Group:	SERVICE MANUAL UPDATE
Bulletin No:	SB-15-039
Issue Date:	11-17-2015

Subject: CORRECTION OF WORKSHOP MANUAL FOR HINO CONVENTIONAL Revision of Troubleshooting Procedure for NOx Sensor

RELEVANT MODEL: 15MY-16MY Conventional Trucks

Inspect the NOx Sensor

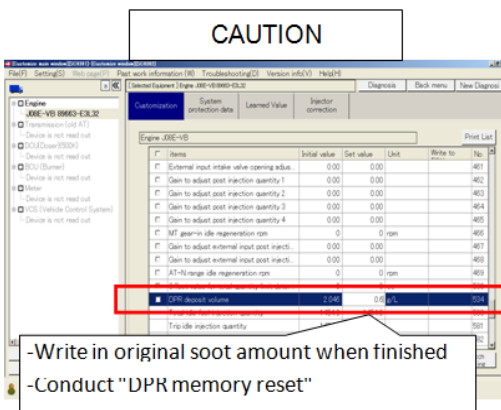
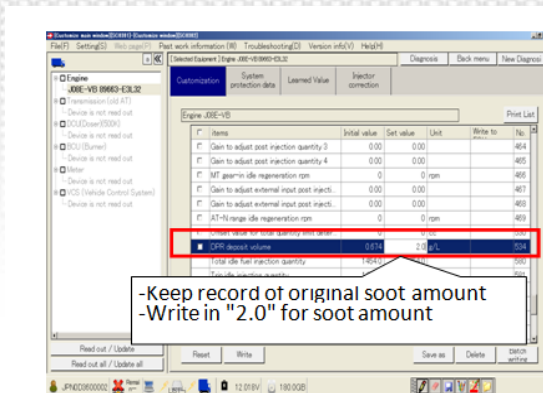
This service manual revision contains updates for the 16MY diagnostic troubleshooting manual. The update changes the method for increasing exhaust temperature, and applies to steps 3 and 4 for DTC's P206B, P207F, P20EE, and 4 and 5 for DTC's P2201 and P2214.

Step 3(upstream) and Step 4(downstream) DTC P206B, P207F, and P20EE

Step 4(upstream) and Step 5(downstream) DTC P2201 and P2214

Note: The instruction below reflects the updates for both the upstream and downstream diagnostics for increasing the exhaust temperature.

- Turn the ignition key to "ON".
- Select [Engine] in the main screen of DX.
- Write in "2.0" for the soot amount in the "Customization" function of DX. (Keep the record of the original value)
- Select [NOx level (before catalyst)], [NOx level (after catalyst)] and the SCR catalyst temperature in the Data Monitor function of DX and start the monitoring.
DXII: [Data monitor Setting and Active test setting] [Data monitor Setting] [NOx level (before catalyst)] and [NOx level (after catalyst)]
- Start the engine.
- Press the DPR manual regeneration switch and start the regeneration.

HINT: Perform DPR regeneration to increase the exhaust gas temperature as the waveform of the NOx sensor can only be detected when the exhaust gas temperature exceeds the specified value.

- Monitor the SCR temperature and the NOx levels (before and after catalyst) in the DX Data Monitor.
- Press the DPR button when the SCR catalyst temperature reaches 250°C, and cancel the regeneration process.
- Determine whether the NOx sensor is functioning properly based on the NOx sensor waveform recorded during monitoring as per the **Performance Verification Manual**.

- Rewrite the soot amount back to the original upon completion of the troubleshooting.
- Conduct DPR memory reset (DTC for abnormal DPR regeneration frequency will come on if not conducted)
